78-6714-02 07/30/99

Direct Connect NEBS Compliance Kit Release Notes

These release notes present information for assuring that your Cisco 6100 system is Network Equipment Building Systems (NEBS) compliant.

Figure 1 DS3 System I/O Card Ferrite Installation

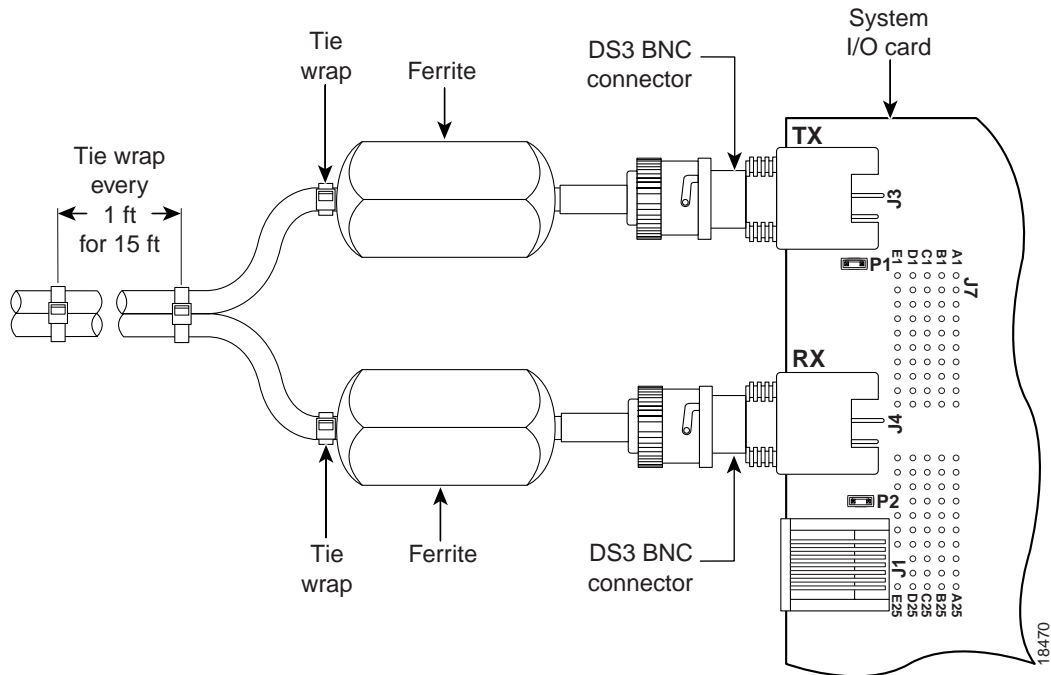
Use the following procedures to add ferrites to the DS3 system I/O card on the backplane of the MC. Figure 1 shows the attachment of the ferrites.

- Step 1** Remove the fuses from the fuse and alarm panel. By removing the fuses from the fuse and alarm panel, the system will not be powered.
- Step 2** Attach coax cables to the two DS3 BNC connectors (J3 and J4) on the left side of the DS3 system I/O card.
- Step 3** Attach one ferrite (36-0087-01, quantity 2) to each of the cables as close to the DS3 BNC connectors as possible.
- Step 4** Place one tie wrap (51-202060, quantity 18) directly behind each ferrite.
- Step 5** Place another tie wrap around both cables where the cables meet after coming from the ferrite, and every 1 foot thereafter for a total of 15 feet.

Figure 3 Cable Looped through Ferrite

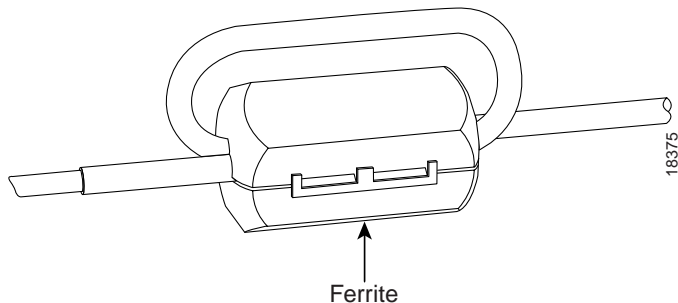
The ferrites included in the NEBS compliance kit must be installed on the cables used to connect the fuse and alarm panel and the power connections on the MC. The cables used to connect the fuse and alarm panel and the power connections should be looped through the ferrite as shown in Figure 3.

Figure 4 Dual-Power Feed Ferrite and Cable Installation

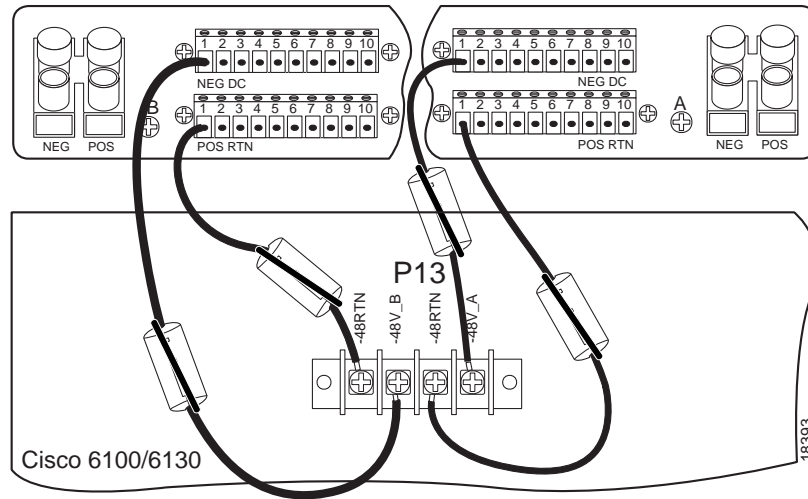
Use the following procedures to add ferrites to the cables connecting the power connections on the backplane of the MC to the fuse and alarm panel for dual-power feed. Figure 4 shows the dual-power feed connections from the MC to the fuse and alarm panel and the attachment of the ferrites to the power connection cables.

- Step 1** Remove the fuses from the fuse and alarm panel. By removing the fuses from the fuse and alarm panel, the system will not be powered.
- Step 2** Wire the -48V_A and -48V_B power connections from the MC (P13) to the fuse and alarm panel NEG DC connectors.
- Step 3** Wire both -48RTN power connections from the MC (P13) to the fuse and alarm panel POS RTN connectors.
- Step 4** Attach one ferrite (36-0087-01, quantity 4) close to the connectors on each of the cables going to the fuse and alarm panel.

Figure 5 Single-Power Feed Ferrite and Cable Installation

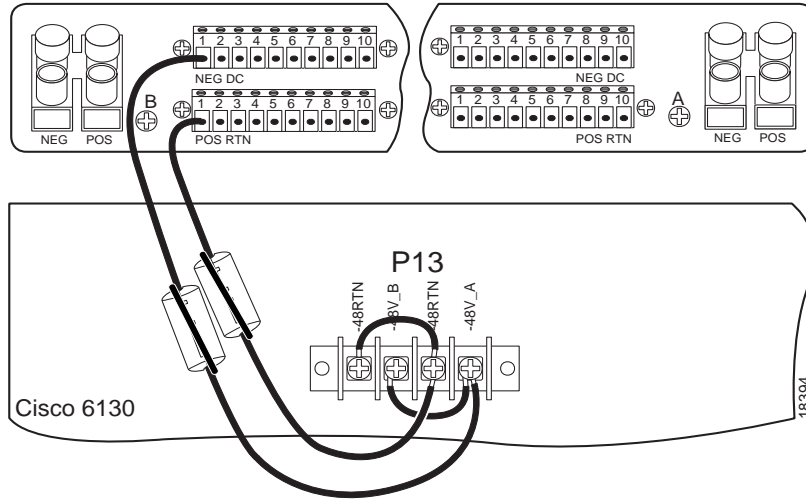
Use the following procedures to add ferrites to the cables connecting the power connections on the backplane of the MC to the fuse and alarm panel for single-power feed. Figure 5 shows the dual-power feed connections from the MC to the fuse and alarm panel and the attachment of the ferrites to the power connection cables.

- Step 1** Remove the fuses from the fuse and alarm panel. By removing the fuses from the fuse and alarm panel, the system will not be powered.
- Step 2** Wire the -48V_B power connection from the MC (P13) to the fuse and alarm panel NEG DC connector.
- Step 3** Wire a -48RTN power connection from the MC (P13) to the fuse and alarm panel POS RTN connector. See Figure 5 for correct placement.
- Step 4** Wire the -48RTNs to each other.
- Step 5** Wire the -48V_A and -48V_B to each other.
- Step 6** Attach one ferrite (36-0087-01, quantity 4) close to the connectors on each of the cables going to the fuse and alarm panel.

Figure 7 Replacement Ground Lugs (22180) Installation

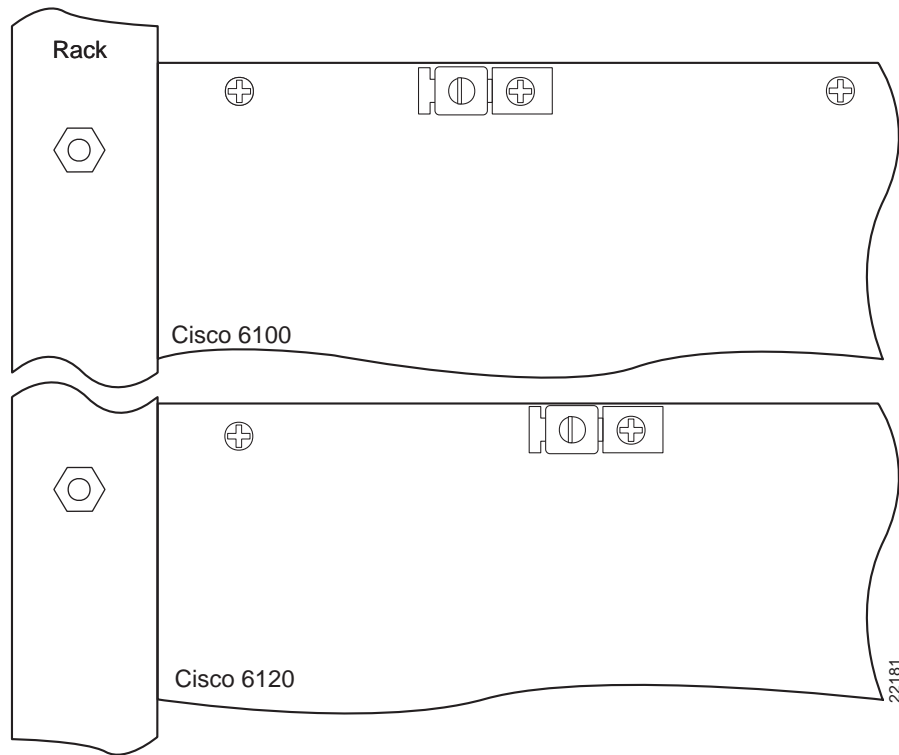
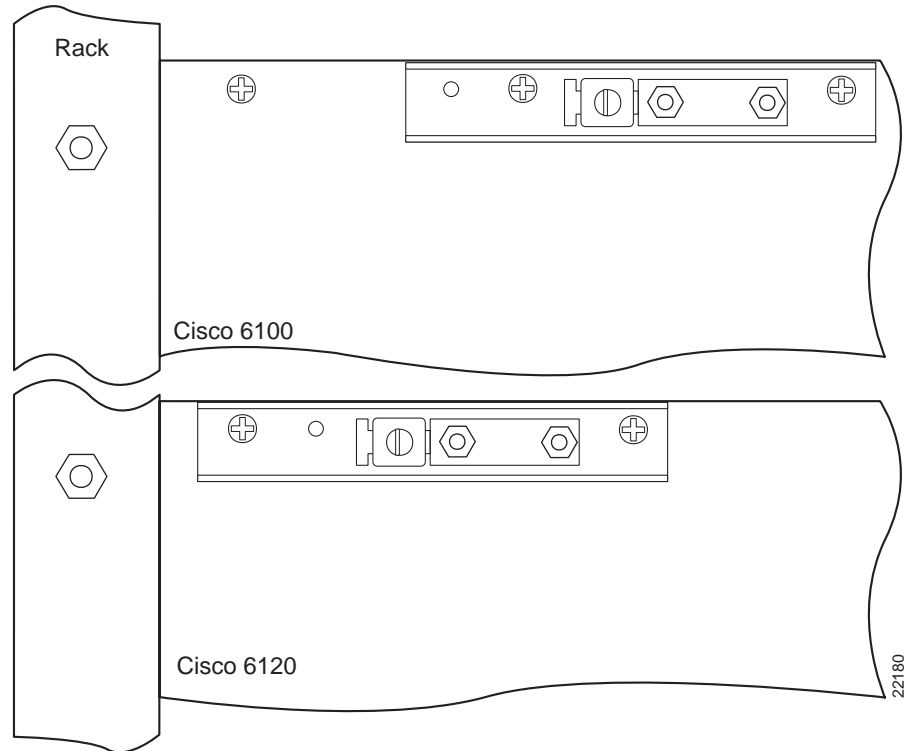
In the upper left corners of the MC and POTS splitter chassis (PSC) are ground lugs used to ground the chassis to the rack. The one hole lugs should be replaced by two hole lugs and a longer bracket. Figure 6 shows the original ground lugs.

Figure 7 shows the replacement ground lugs on both chassis

- Step 1** Remove the fuses from the fuse and alarm panel. By removing the fuses from the fuse and alarm panel, the system will not be powered.
- Step 2** Remove the original ground lug by removing the one screw and lug.
- Step 3** Attach the new, longer bracket (700-04424-01) using both original screws. These screws should be in the second and third holes from the upper left corner of the MC.
- Step 4** Attach the two hole lug (32-0621-01) to the adapter bracket using the two nuts (49-0401-01).
- Step 5** Reinsert the fuses in the fuse and alarm panel. By reinserting the fuses, the system will become powered.

- Step 1** Remove the fuses from the fuse and alarm panel. By removing the fuses from the fuse and alarm panel, the system will not be powered.
- Step 2** Remove the original ground lug by removing the one screw and lug.
- Step 3** Attach the new, longer bracket (700-04424-01) using both original screws. These screws should be in the first and second holes from the upper left corner of the PSC.
- Step 4** Attach the two hole lug (32-0621-01) to the adapter bracket using the two nuts (49-0401-01).
- Step 5** Reinsert the fuses in the fuse and alarm panel. By reinserting the fuses, the system will become powered.

Figure 8 DS3 System I/O Card ESD Shield Installation

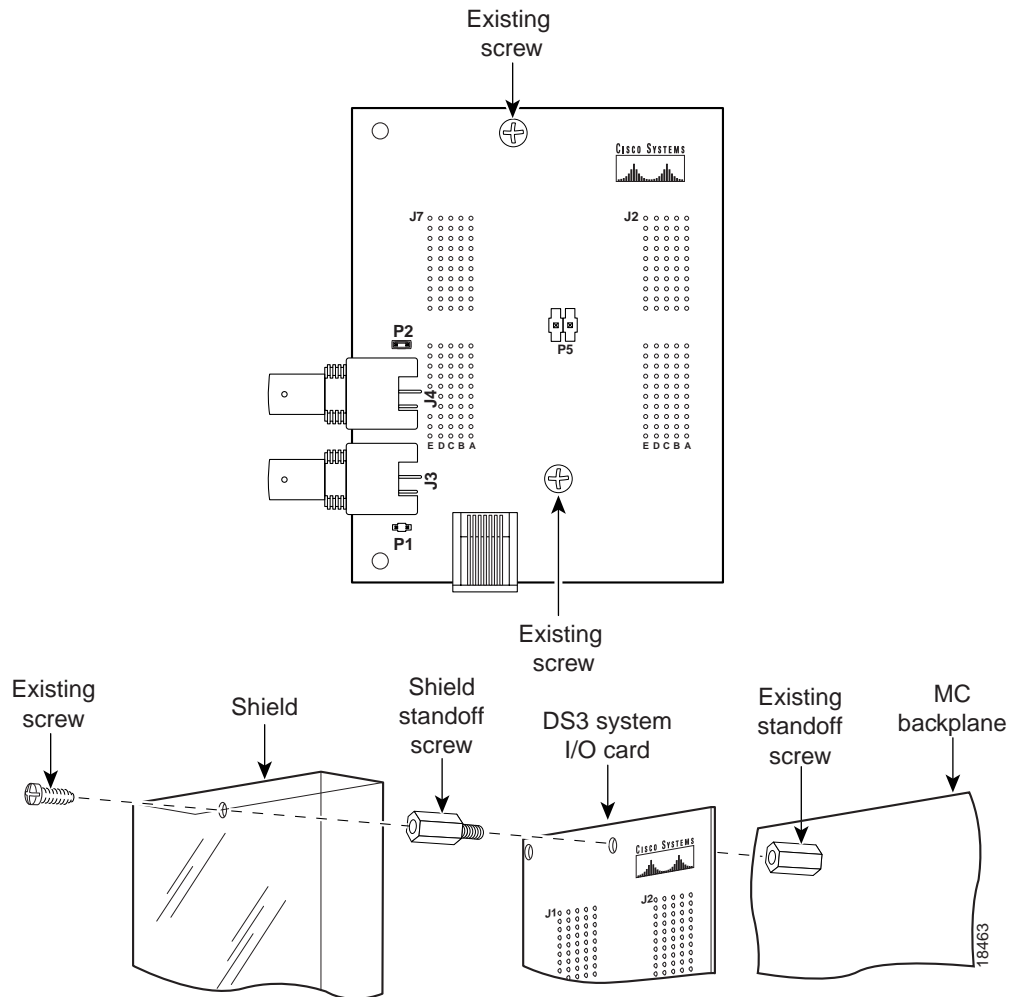
A plastic ESD shield should be mounted over the DS3 system I/O card. Use the following procedures to add the ESD shield. Figure 8 shows the addition of the ESD shield.

- Step 1** Remove the fuses from the fuse and alarm panel. By removing the fuses from the fuse and alarm panel, the system will not be powered.
- Step 2** Remove the two screws holding the DS3 system I/O card to the two existing standoff screws attached to the backplane of the MC. Be careful that the card does not fall away from the connectors.
- Step 3** Add additional standoff screws (50-0767-01) by screwing them through each of the screw holes in the DS3 system I/O card and into the original standoff screws.
- Step 4** Position the holes in the plastic ESD shield (700-04921-01) over the new standoff screws and use the original screws from Step 1 to attach the shield to the new standoff screws.
- Step 5** Reinsert the fuses in the fuse and alarm panel. By reinserting the fuses, the system will become powered.

Figure 9 MC Thermal Shield Installation

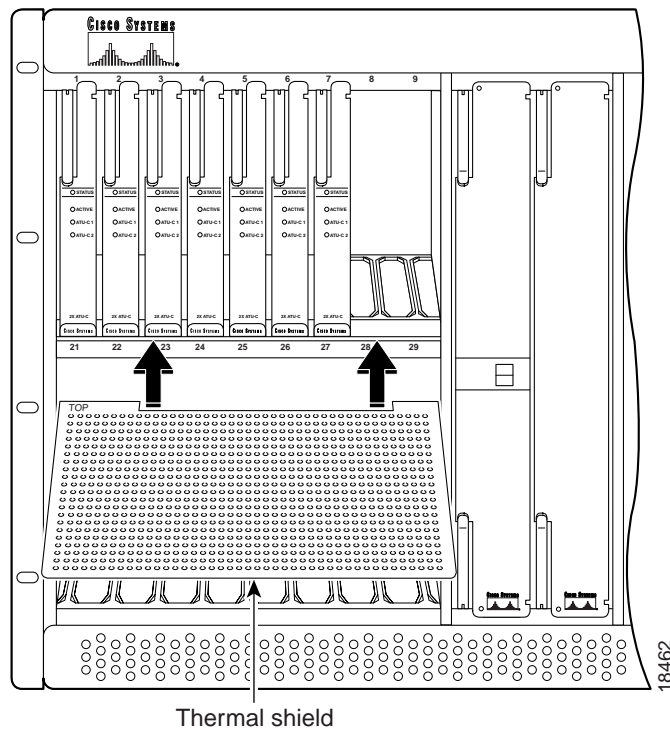
A thermal shield is required between the two shelves of the MC to meet NEBS compliance. Use the following procedures to place the thermal shield between the shelves. Figure 9 shows the placement of the thermal shield in the MC.

- Step 1** Make sure that provisioning is such that subscribers will not lose service when you remove all the modules from either quadrant on the lower shelf of the MC.
- Step 2** Remove all the modules from the lower shelf on the left side of the MC.
- Step 3** Insert the thermal shield (700-04630-01) in the space between the upper and lower shelves. The shield orientation should be with the notch in the back and offset to the right, knife edge toward the rear of the chassis, rounded edges away from the rear of the chassis, and the arrow on the shield up.

Figure 10 Front Door Replacement with Gaskets

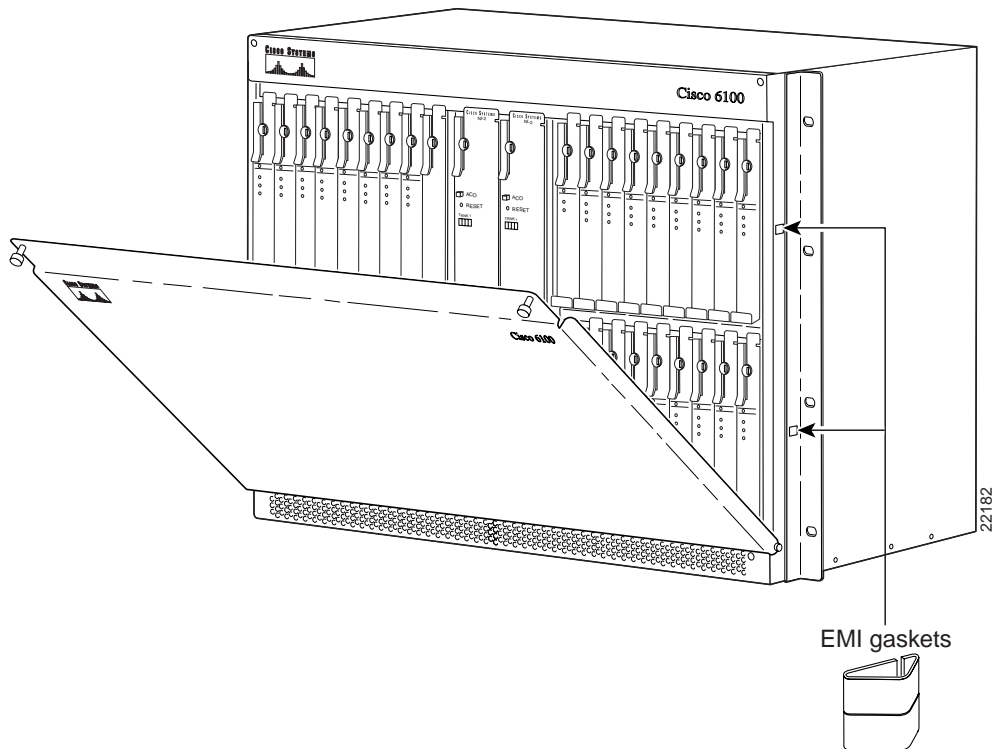
Use the following procedures to replace the front door of the MC chassis with a new stiffened door and EMI gaskets on the chassis. Figure 10 shows the replacement of the front door and the addition of the gaskets.

- Step 1** Remove the original door from the MC.
- Step 2** Attach the new stiffened front door (700-03491-02) at the base of the lower shelf of the MC.
- Step 3** Add two gaskets to either side of the chassis frame in the positions shown in the figure below.
- Step 4** Use the screws in the upper corners of the door to close it firmly over the front of the chassis.

Figure 11 Label Replacements

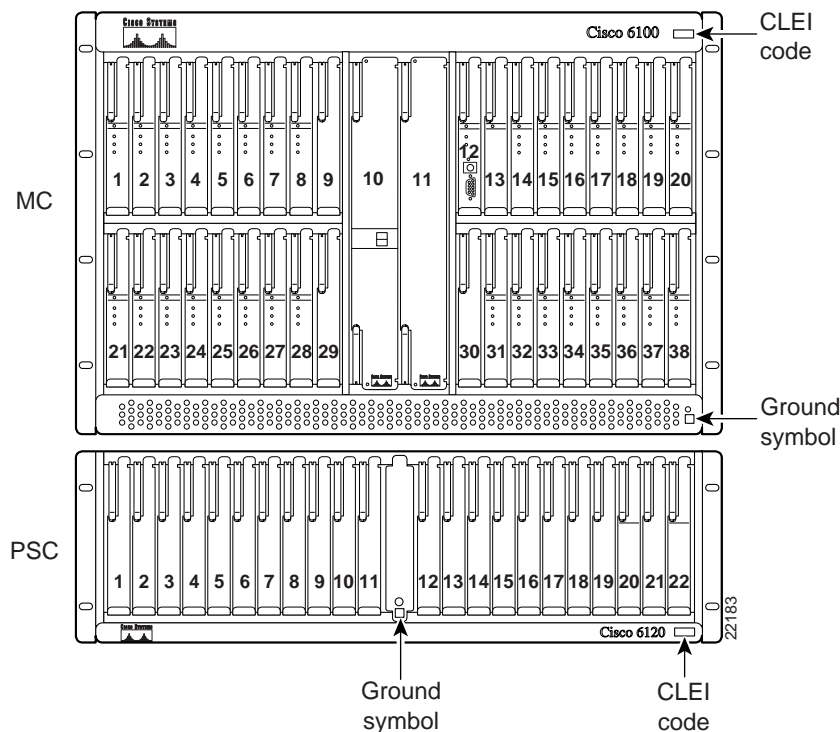
The grounding symbols, CLEI codes, and PSC 800 number labels should replace the current labels on the chassis. Figure 11 shows the positions of the labels being replaced.

- Step 1** Replace the original CLEI code label in the upper right corner of the MC with the new CLEI code label SLMT7H0BRA.
- Step 2** Replace the 800-04390-02 label on the right side of the chassis with the new 800-04390-03 label.
- Step 3** Replace the original ground symbol label in the lower right corner of the MC with the new one.

- Step 1** Replace the original CLEI code label in the lower right corner of the PSC with the new CLEI code label SLMT9K0BRA.
- Step 2** Replace the 800-04325-03 label on the right side of the chassis with the new 800-04325-04 label.
- Step 3** Replace the original ground symbol label in the lower center of the PSC with the new one.
